Borrego Springs Watermaster

Technical Advisory Committee Meeting

June 10, 2026

High-Level Borrego Valley Hydrologic Model Review

Subsurface Groundwater Exchanges

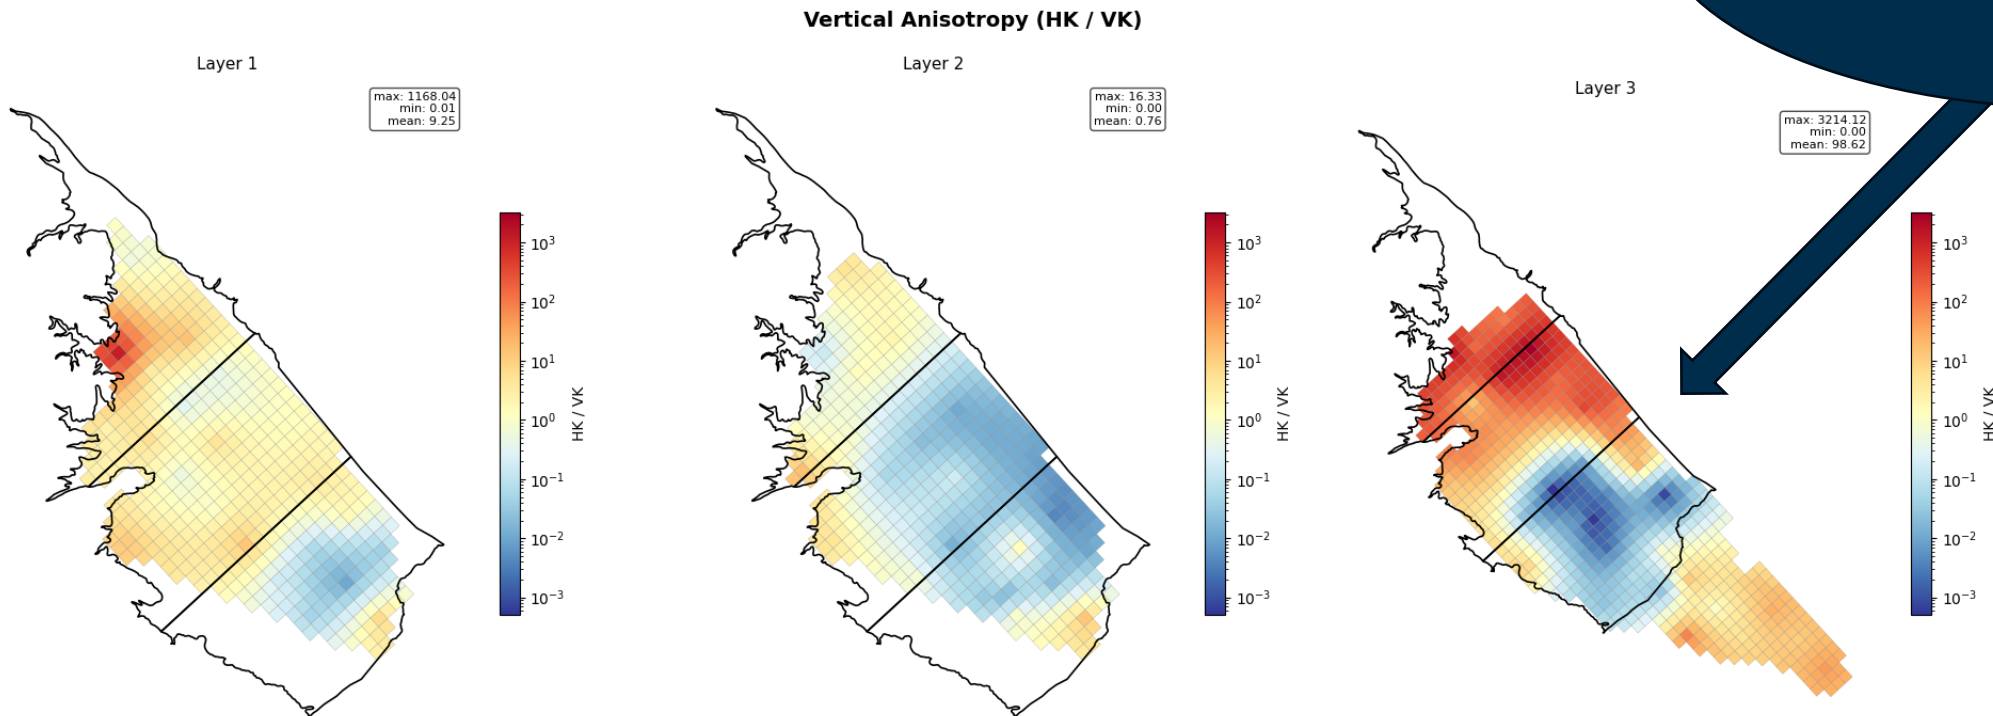
Consequence

- If pumping moved northward, that might slow recovery of natural flow conditions & reduce groundwater availability in CMA and GDEs

Hydrogeologic Model Evaluation

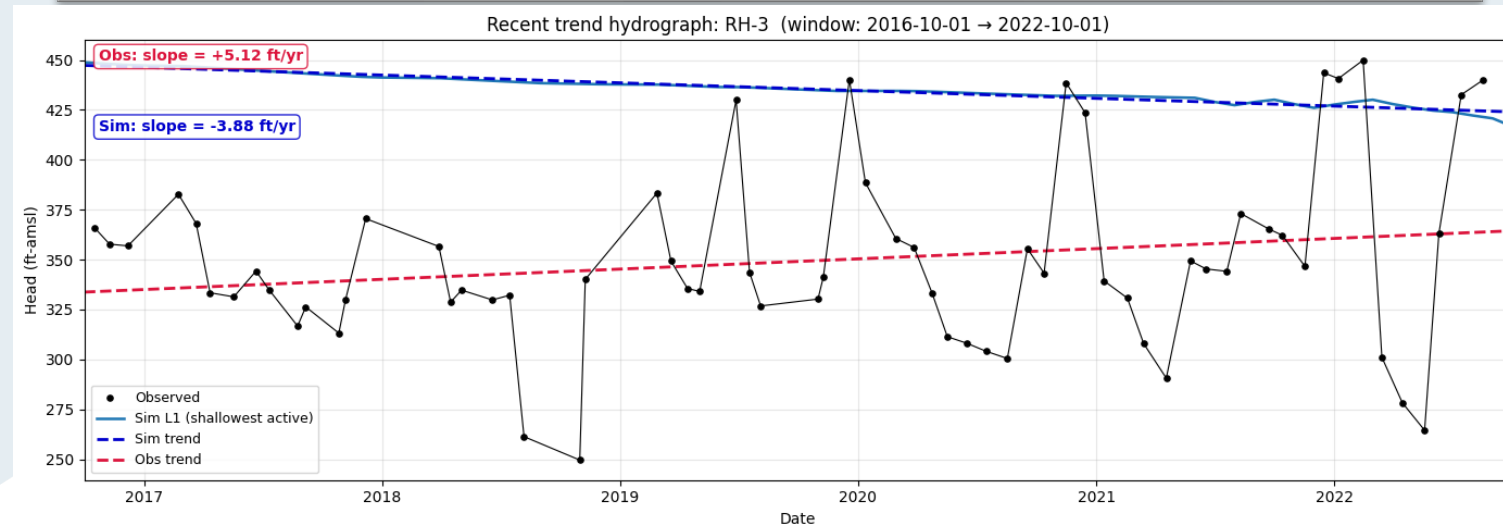
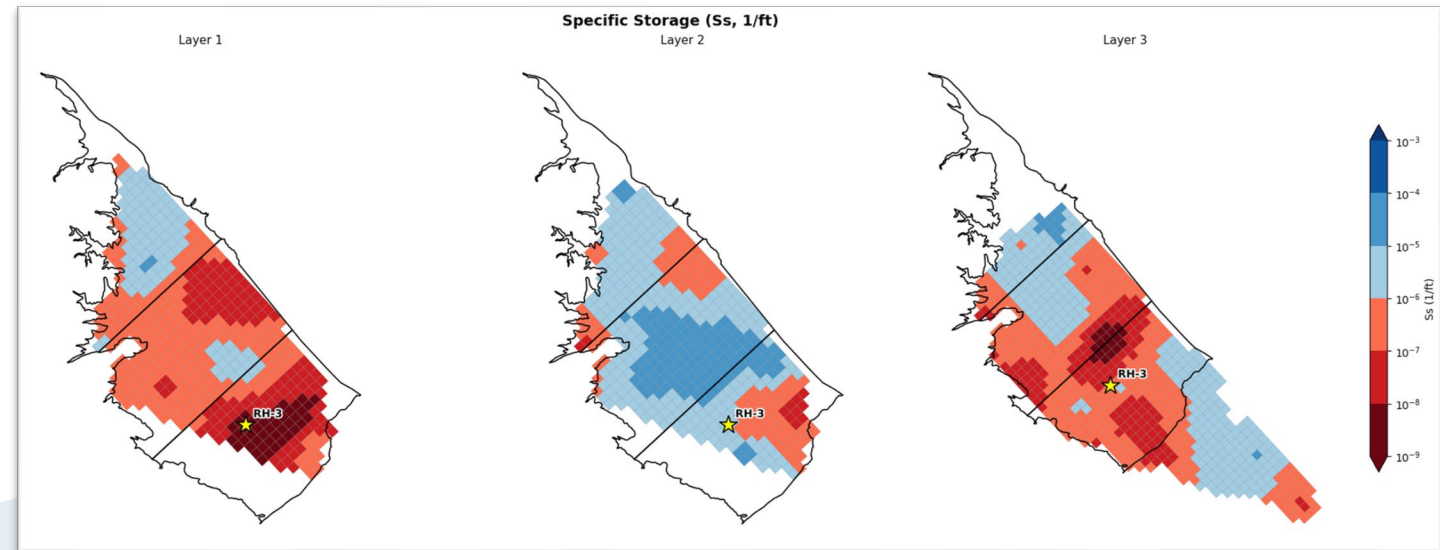
BVHM simulates unrealistic aquifer parameters, particularly in CMA & SMA

Storage values are too low:

- We expect values on the order of 10^{-6} 1/ft
- We see values approaching 10^{-9} 1/ft in some areas

Consequences:

- Large model errors in SMA
- Overestimated long-term decline in water levels
- Model may not be able to pump specified water

Groundwater Dependent Ecosystems

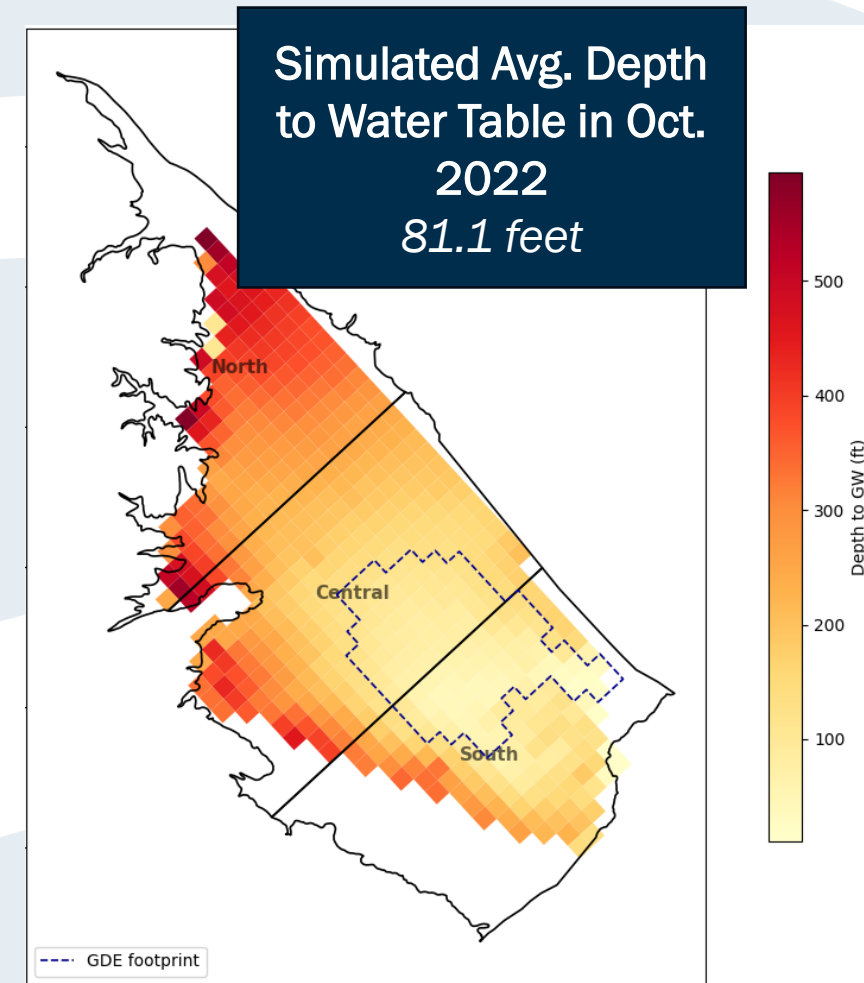
BVHM may underestimate
GDE water use

Documented rooting depths for mesquite species:
39 to 175 feet

BVHM simulated rooting depth:
22.9 feet

Consequence

- Model simulates minimal water use in mesquite bosque region because the simulated water table is deeper than the simulated rooting depth

Net GW outflux from Farm Package (processed using ZoneBudget)
for the GDE zone, comparing three scenarios with different rooting depths

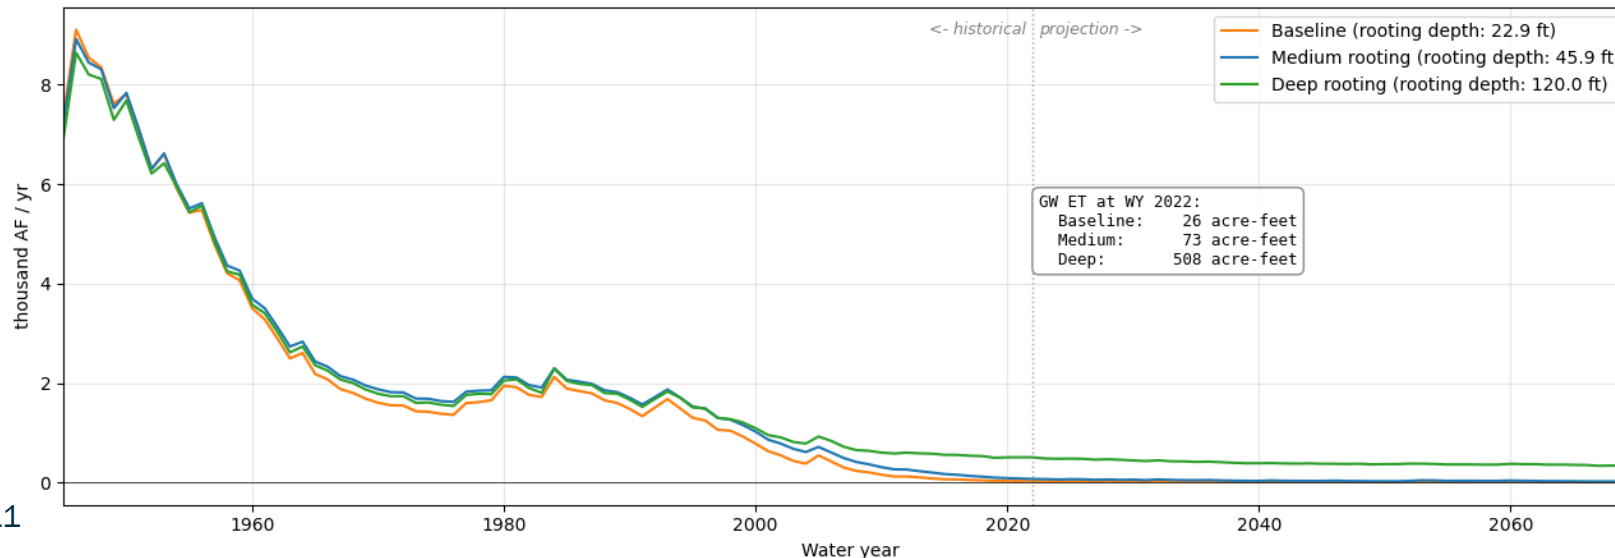
BVHM may underestimate
GDE water use

Baseline simulated mesquite bosque water use:

WY 1950: ~8,000 acre-feet per year

WY 2022: 26 acre-feet per year

Deeper simulated rooting depths (120 ft deep)

WY 2022: 508 acre-feet per year

Take-away

- Simulating deeper rooting depths didn't make as much of a difference as expected
- Further exploration & comparison against UC Irvine study of estimated GDE transpiration is needed

Groundwater Dependent Ecosystems

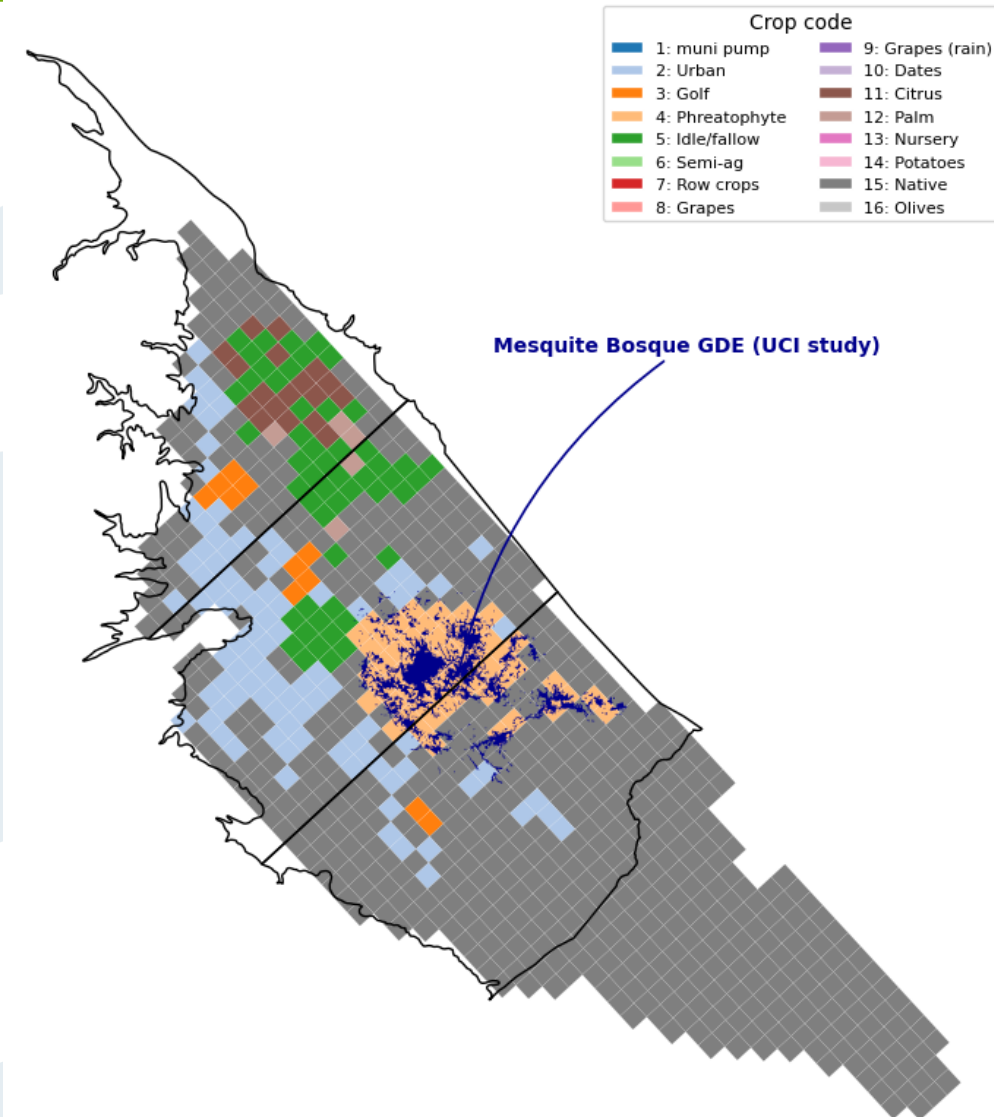
BVHM may underestimate
GDE water use

Key GDE simulated in model appears to be
mesquite bosque

- Phreatophyte land use class in BVHM corresponds with UC Irvine study

What about tamarisk?

- Often used as a windbreak
- Expected to be more distributed throughout the basin
